Panel Reference	PPSSSH-61
DA Number	DA2020/0387
LGA	Georges River Council
Proposed Development	Demolition of existing buildings and construction of a new multi-storey mixed use facility for church and community purposes.
Street Address	23 Dalcassia Street, Hurstville
Applicant/Owner	Applicant: The Salvation Army (NSW) Property Trust Owner: The Salvation Army (NSW) Property Trust
Date of DA lodgement	13 October 2020
Number of Submissions	Three (3) submissions
Recommendation	Refusal
Regional Development Criteria (Schedule 7)	Pursuant to Clause (5)(b) of Schedule 7 of <i>State Environmental Planning Policy (State and Regional Development) 2011</i> ('SRD SEPP'), the proposal is classified as Regionally significant development as the development is for <i>community facilities</i> and a <i>place of public worship</i> with a CIV over \$5 million.
List of all relevant s4.15(1)(a) matters	<ul style="list-style-type: none"> • <i>State Environmental Planning Policy (State and Regional Development) 2011</i> • <i>State Environmental Planning Policy (Infrastructure) 2007</i> • <i>State Environmental Planning Policy No 65 – Design Quality of Residential Apartment Development</i> • <i>State Enviro

Figure 14: Proposed Ground Floor Plan (Source: Integrated Design Group, September 2020)

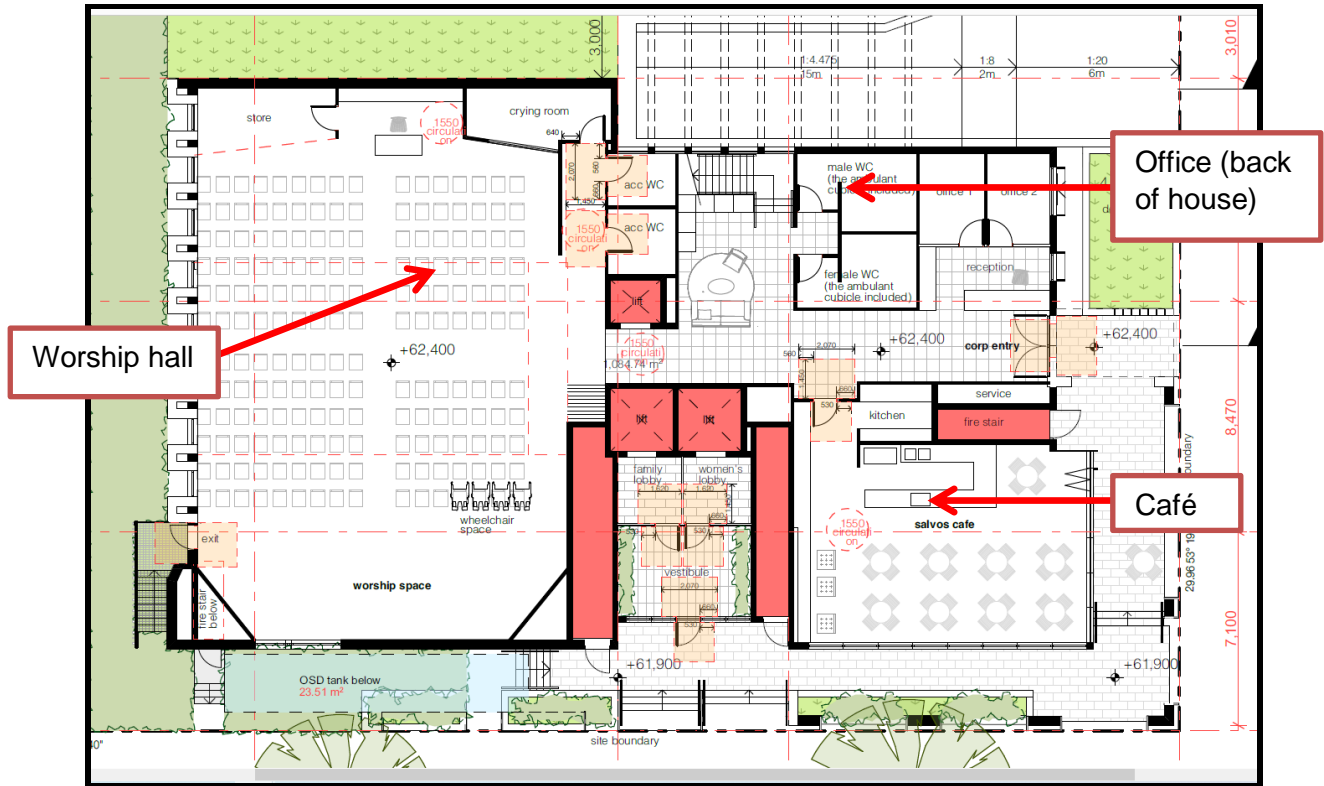
As per the Ground floor plan (Drawing 1100, Integrated Design Group, September 2020), the building provides nil setback to the corner of Dora and Bond Streets and increased setbacks to the remaining street-front boundaries.

As per the Ground floor plan (Drawing 1100, Integrated Design Group, September 2020), the basement driveway is exposed along the eastern boundary. It appears that there are precedents of similar driveway locations established by the other RFB type developments in the vicinity of the subject site. Nevertheless, it presents a poor outcome resulting in adverse impact to surrounding public and private domain areas. To meet ADG guidelines (3H-1) and prevent visual dominance, the driveway is recommended to be encapsulated within the built form and integrated into the composition of the front façade. Currently, the driveway occupies almost 50% of the side setback, leaving insufficient capacity for deep soil landscape screening along the common boundary.

The ground floor plan (Drawing 1100, Integrated Design Group, September 2020) has not suggested where the fire stair will be connected. However, it could be estimated from upper-level plans that the fire stairs are likely to end within the lift lobby, which is a safety concern.
